Application for Land Use Action

Master File #: DR-2017-001

Re: Axletree Apartments Application for Land Use Action

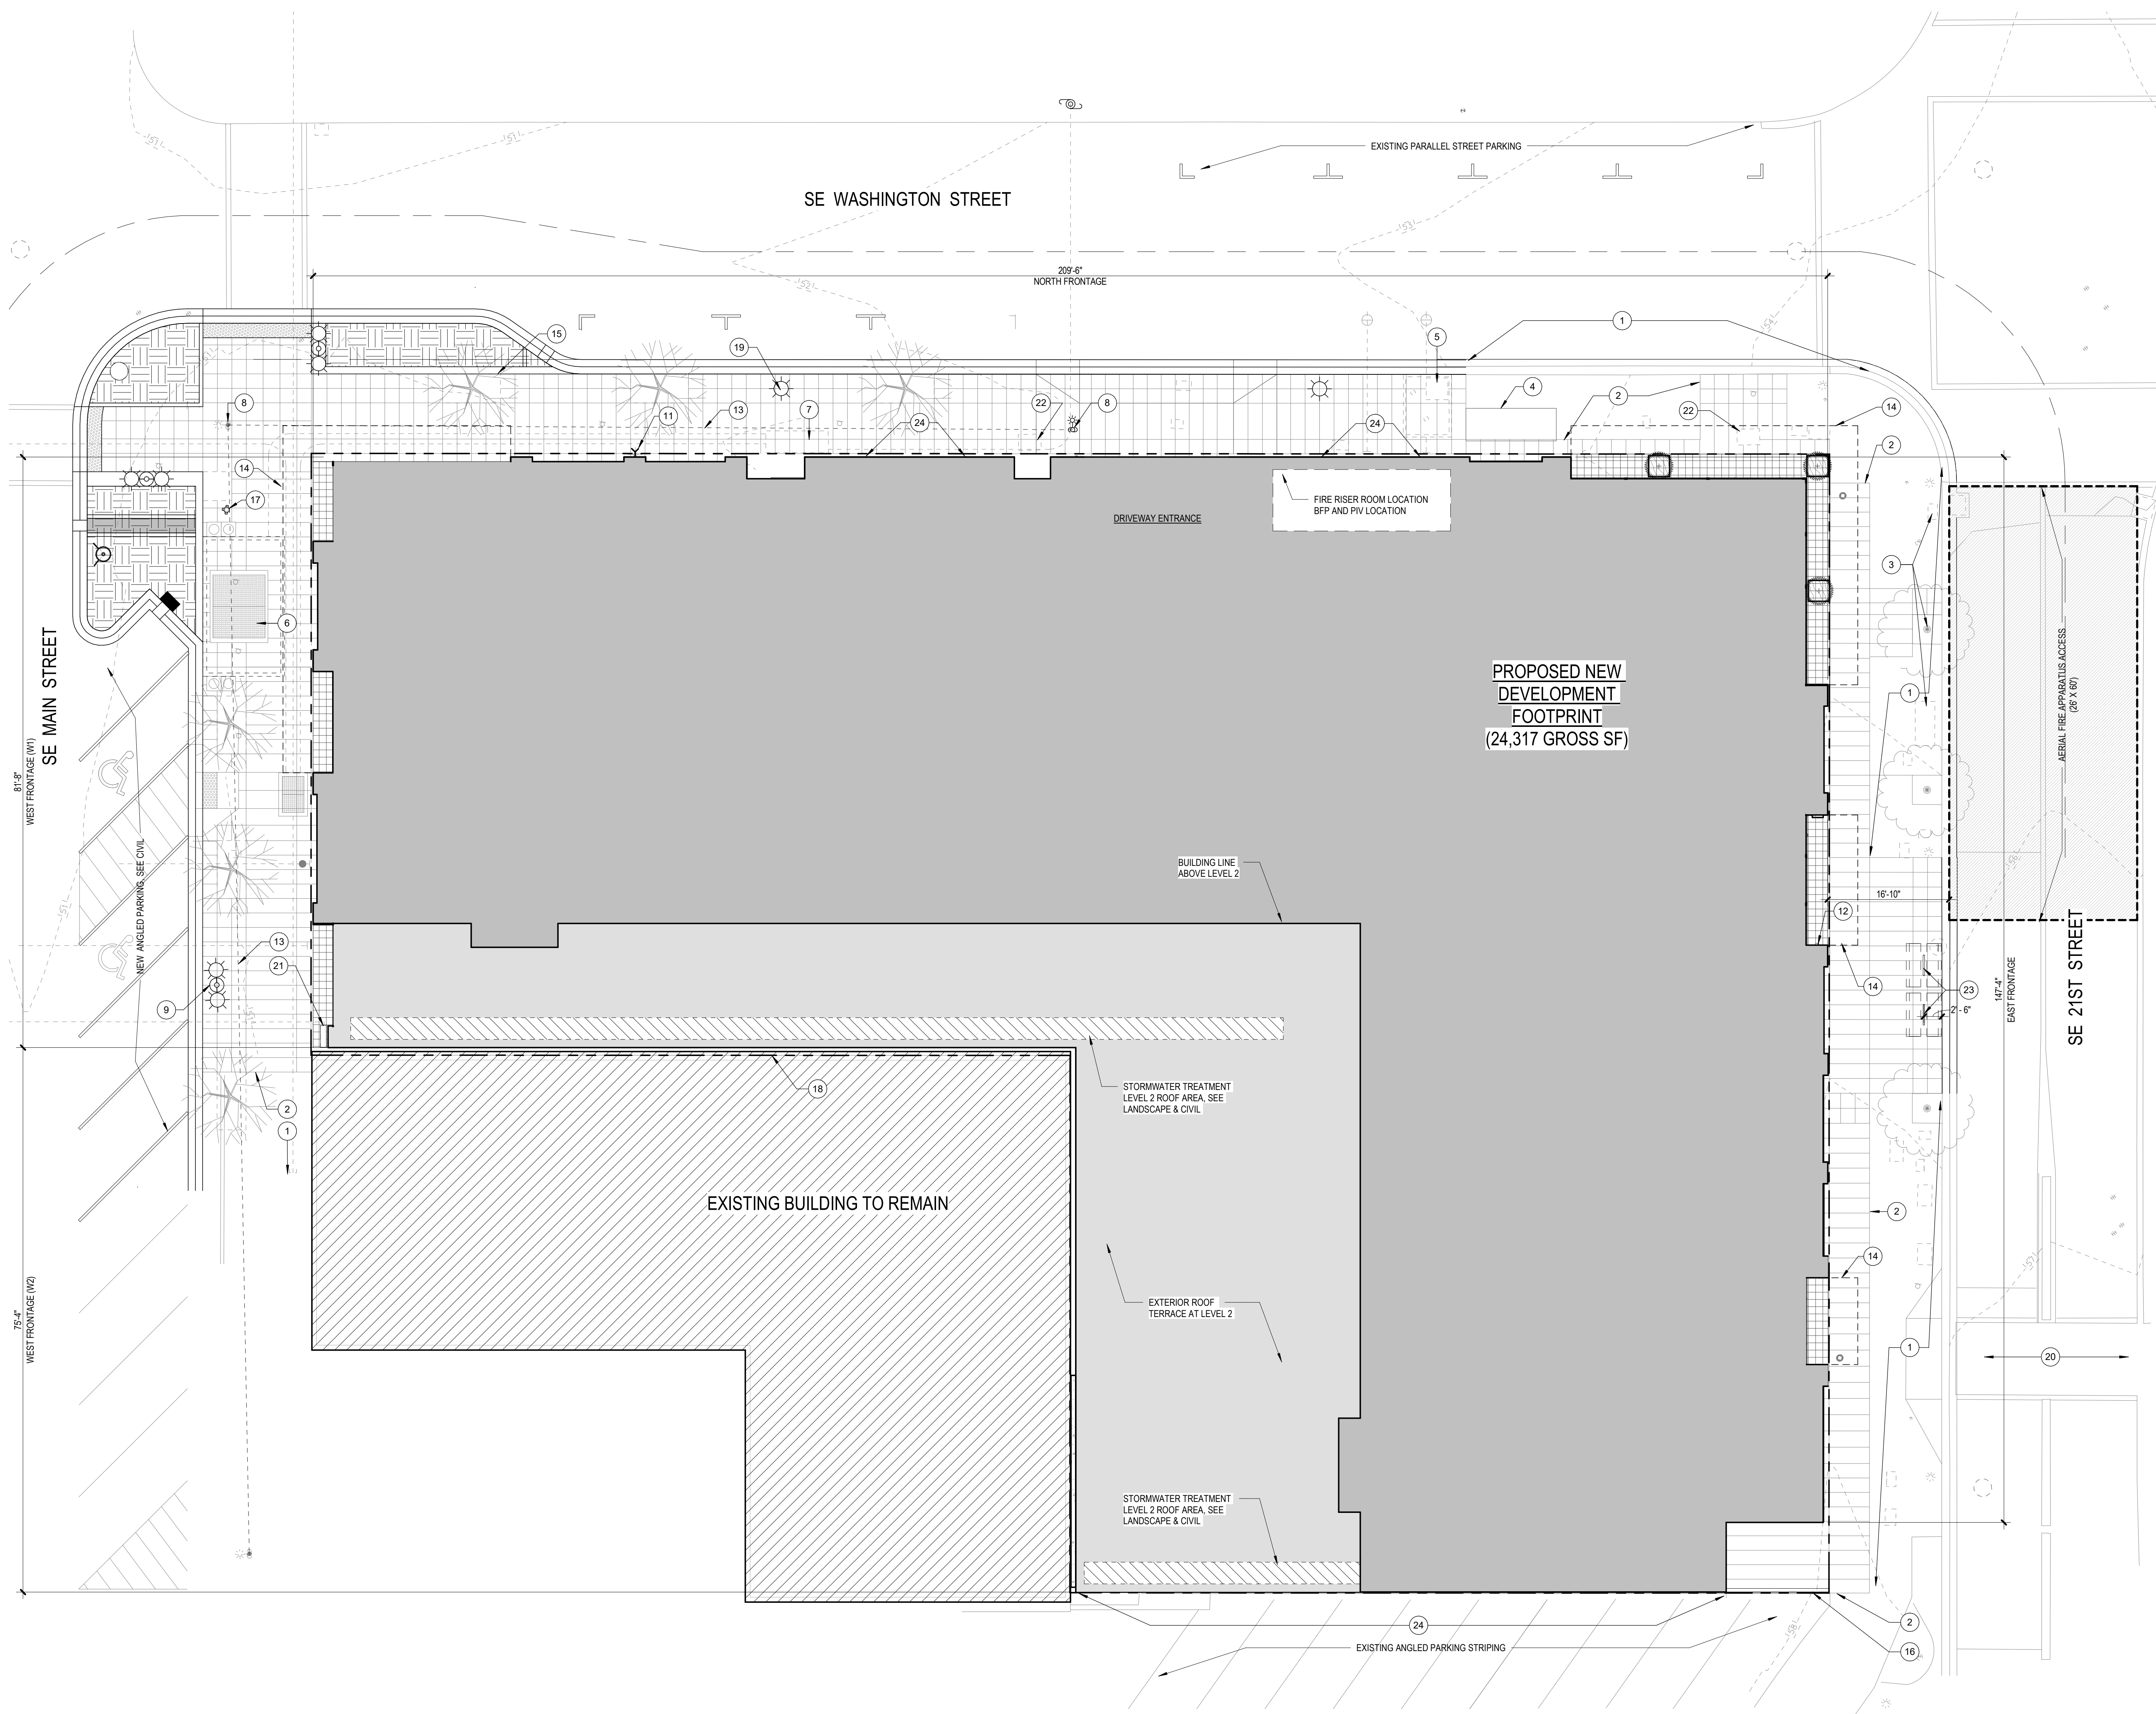
Removal of 4 transom windows to enhance public art. Removal of window area still provides the percentage of transparency required by code. Please see "Window Area Calculations" sheet.

The approved design for the north elevation of the Axletree Apartments includes four locations where metal panels of public art are to be installed. The locations are “framed” between 1” deep pilasters with transom windows above. The transom windows were included in the design to increase storefront transparency beyond the required 40%, and the removal of the windows still maintains the code required area. The success of the transom windows as-designed is limited because they are in the exterior walls of the electrical and sprinkler rooms, utilitarian and unoccupied.

Permitted Design with transom windows

Proposed Design with "backlite" full height perforated metal art panels.

NORTH ELEVATION - WINDOW AREA CALCULATIONS:

LEVELS 2-5 WALL AREA - 9,439 SF (100%)
 WINDOW AREA - 3,416 SF (36%)

GROUND FLOOR WALL AREA - 3,064 SF (100%)
 STOREFRONT AREA - 1,262 SF (41%)
